Access Compliance Report Public Rights-of-Way (Pedestrian Signals)

Main Street: CRAWFORD_CANYON_RD Cross Street: CHAPMAN_AVE Location: SW

ADA ID: SGRK211007170745 Signal Type: One Push Button-Non APS Overall Compliance: No Severity Scores: BTN 1: 35 BTN 2: N/A No BTN: N/A

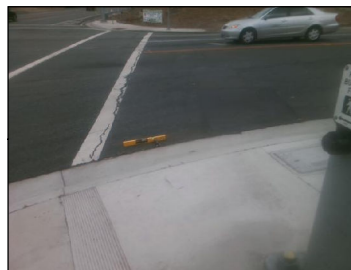
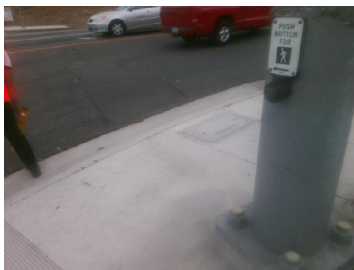
OC Std/PROW: MUTCD 4e.08, R404.2, R404.3

Possible Solutions: Replace Signal Push Button With APS Button. Remove & Relocate Sign.
